SERVICE INFORMATION LETTER

Subject: Incorrect Part marking of Wencor ATS Seal Assembly

Figure 1, Rib Configuration

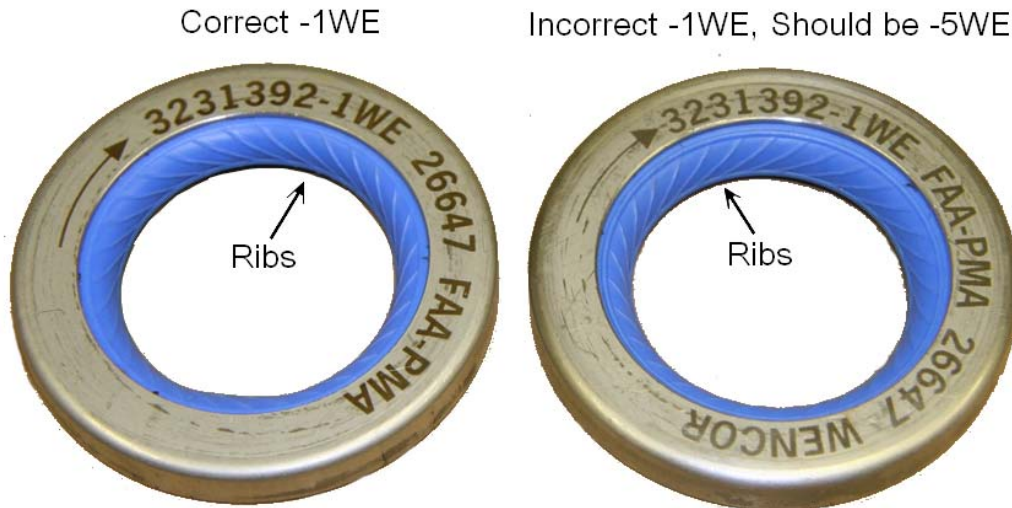
A single manufacturing lot of the Wencor Seal Assembly PN 3231392-1WE was manufactured with the directional ribs configured to match PN 3231392-5WE, but was marked incorrectly as PN 3231392-1WE. The -1WE and the -5WE are identical except for the rib configuration as shown in Figure 1.

For ATS serviced after December 2011 verify that the correct Seal Assembly rib configuration is installed (see Figure 1). If not, remove and replace the Seal Assembly with the correct one per the instructions in the ATS CMM. Return the misidentified Seal Assembly to Wencor. Record accomplishment of this SIL in the ATS overhaul log book.

Figure 2, Installed Seal Assembly

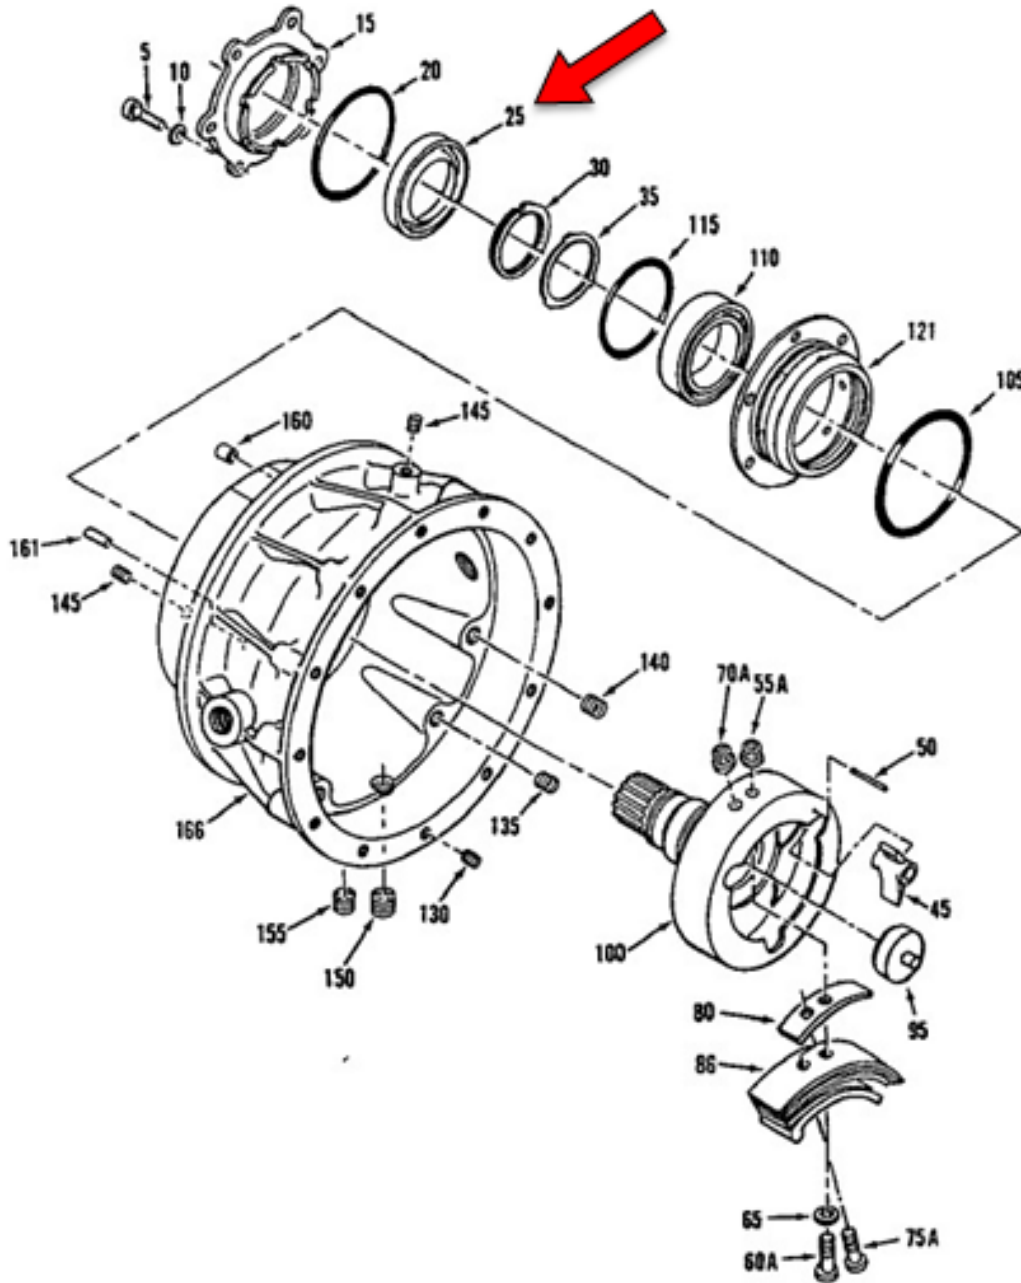
The Seal Assembly is designed to prevent oil leakage from the output shaft chamber of the Air Turbine Starter (ATS). The directional ribs are a product improvement designed to redirect oil back into the ATS as the output shaft rotates. It is possible that oil leakage might occur if the Seal Assembly with the incorrect rib configuration is installed. Signs of oil leakage can be observed by oil leaking from the output chamber. See example of installed Seal Assembly in Figure 2.

For ATS installed with the Wencor Seal Assembly after December 2011, visually inspect the ATS for signs of excessive oil leakage from the output chamber in accordance with the approved aircraft maintenance program that exceed the limits defined in the ATS CMM. If excessive leakage is found, remove and replace the ATS per the instructions in the AMM. Record accomplishment of the removal of the ATS as instructed per this SIL in the aircraft overhaul log book.
